ADDENDUM No. 03

Subject: Wright Elementary School – Major HVAC Renovation
SDP Contract No.

This ADDENDUM dated 1/26/2022 shall modify and become part of the Contract Documents for the work of this project. Any items not mentioned herein, or affected by, shall be performed strictly in accordance with the original documents, unless modified by prior addenda, if any.

1 CHILLER PAD AND FENCE ENLARGED PLAN
SCALE: 1/4" = 1'-0"

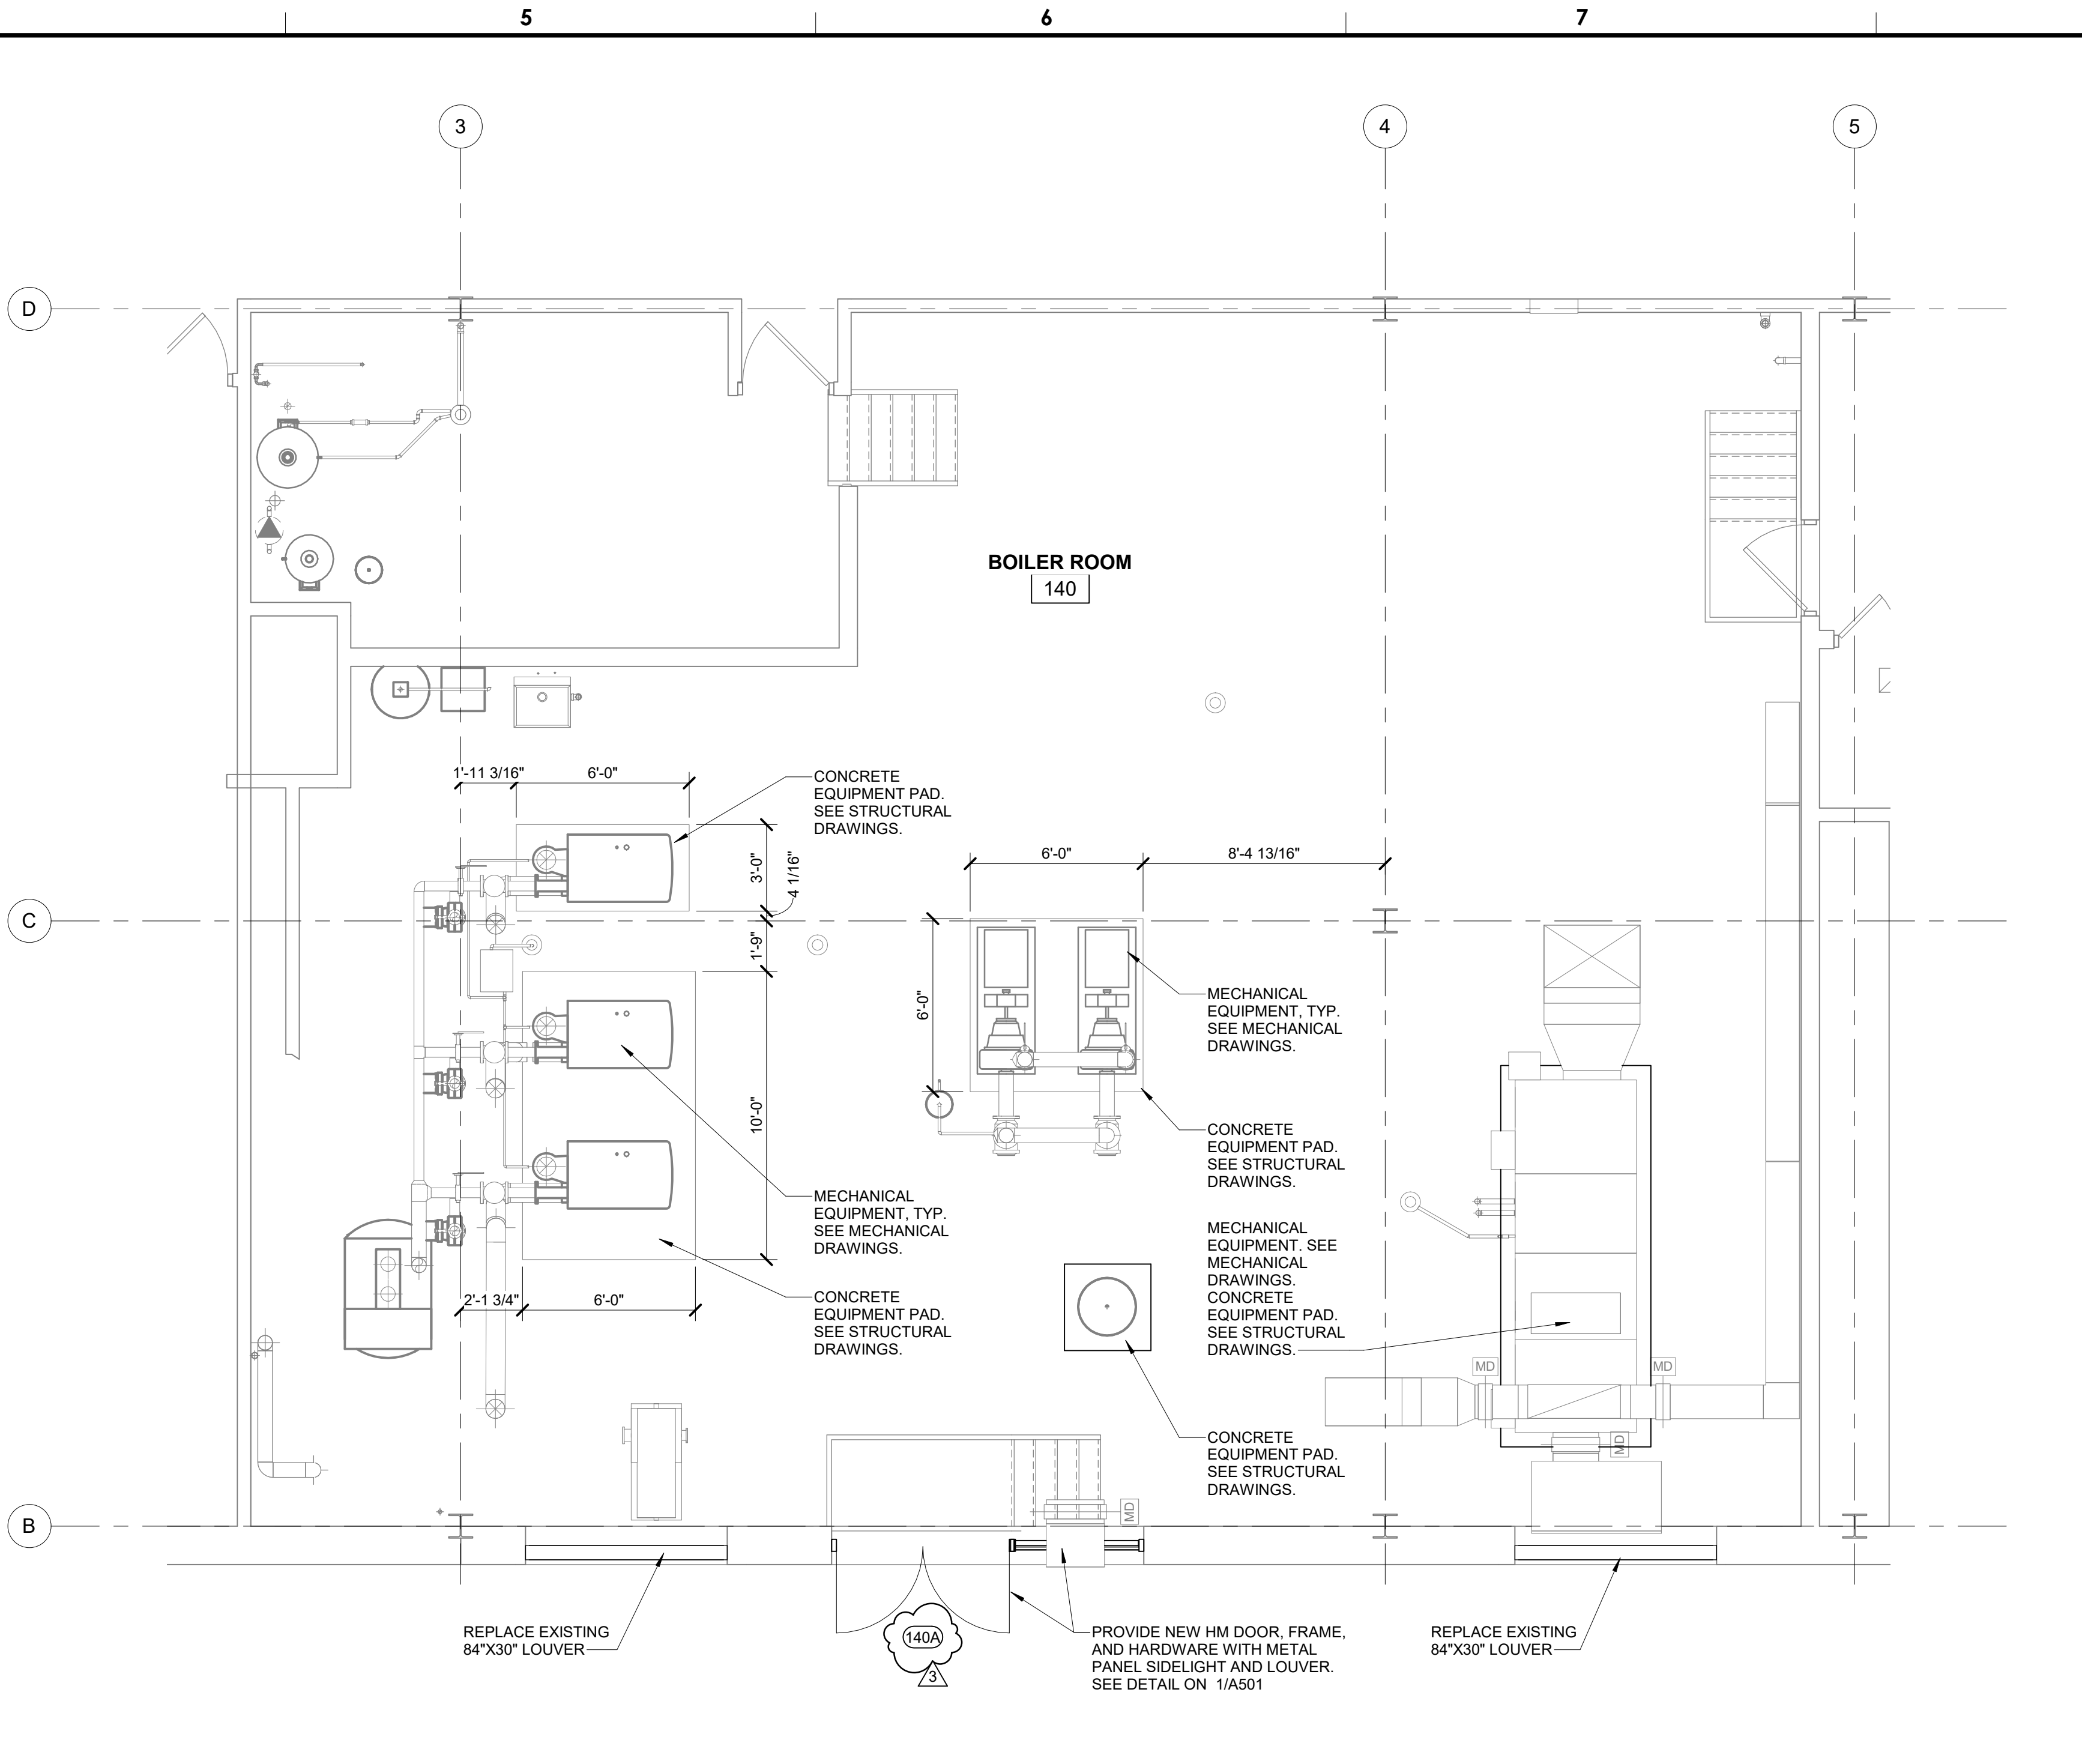
Does the Expansion tank need a new concrete pad?

Does the AHU need a new concrete pad?

Drawing A 401 indicates details for the Chiller pad is on the structural drawings, but none are.

Yes. General Contractor is to provide a new 4" high concrete pad that extends 6" (on all sides) past the equipment footprint is required. See attached A401.

Yes. General Contractor is to provide AHU-4 with a new 4" high concrete pad that extends 6" (on all sides) past the equipment footprint is required. See attached A401. Other AHUs are supported from supplemental steel above the roof.

See revised S001 attached.

DRAWING NAME
ARCHITECTURAL DETAILS

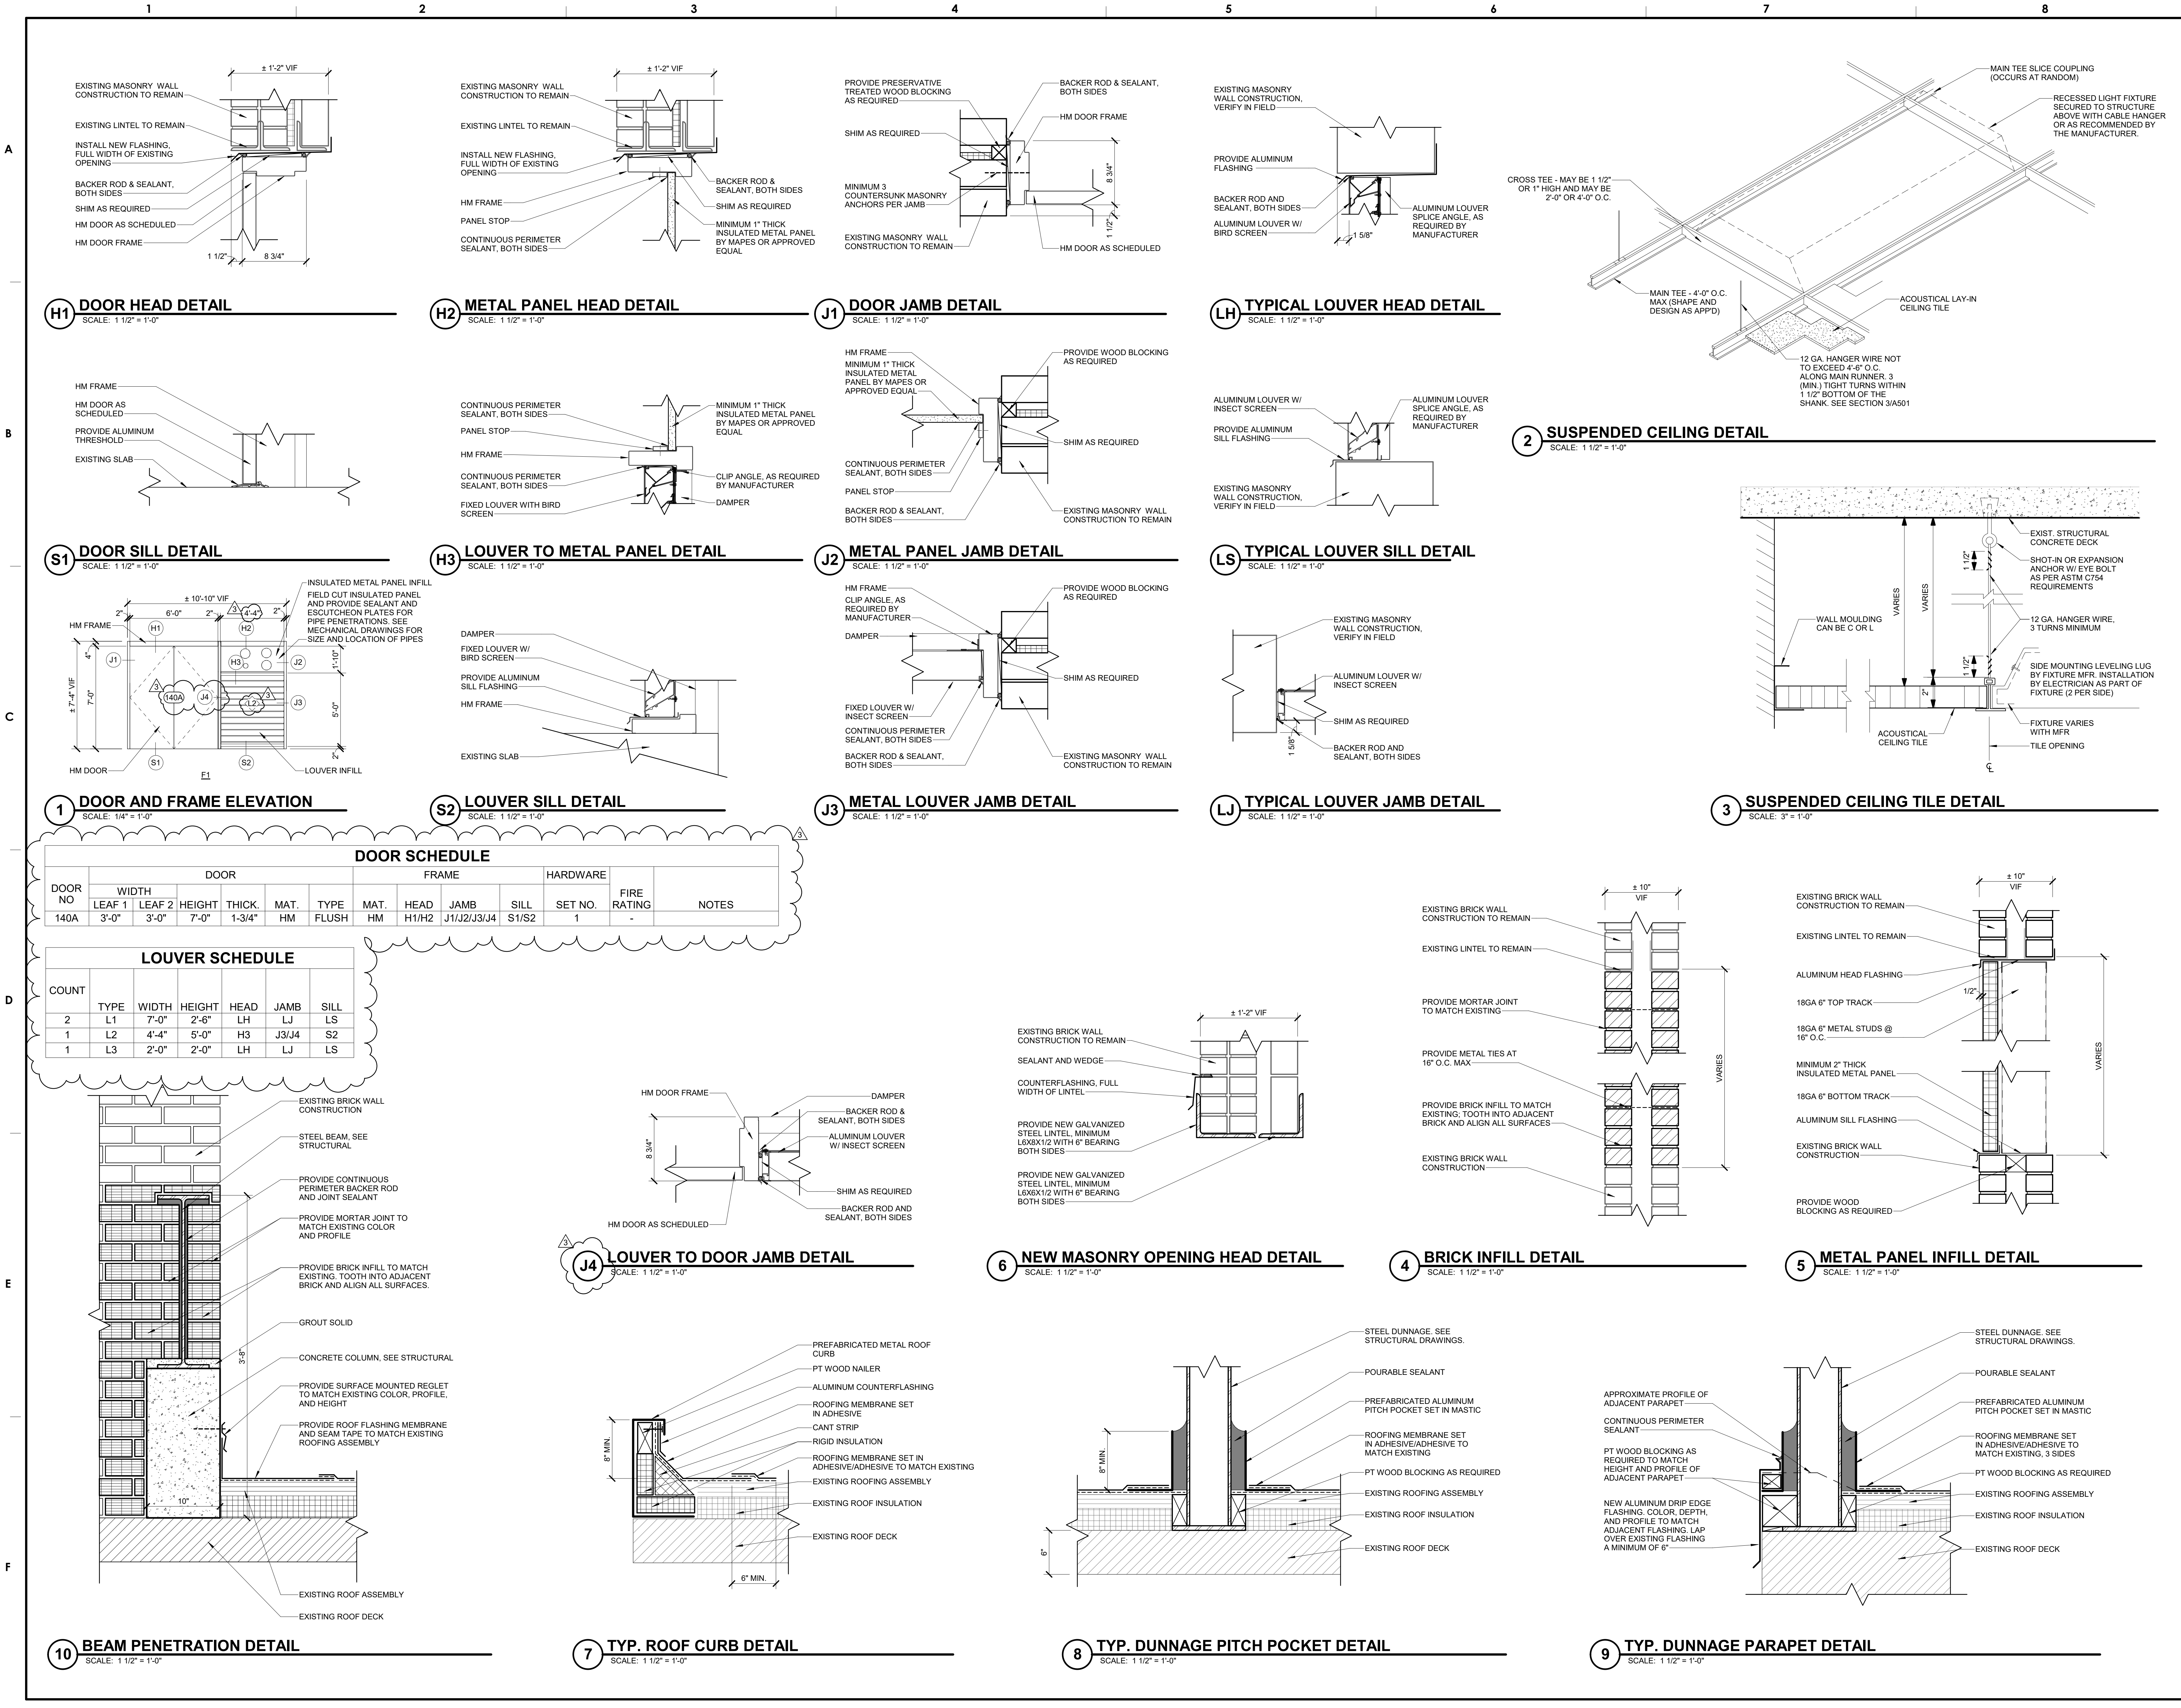
Drawing AD 101 & MD 401 do not agree with reference to the louvers. Please clarify.

Is there a louver schedule? Please clarify.

Architectural plans take precedence. General Contractor to provide louvers per architectural drawings. See schedule on attached A501 as amended.

Yes. See attached A501 as amended.
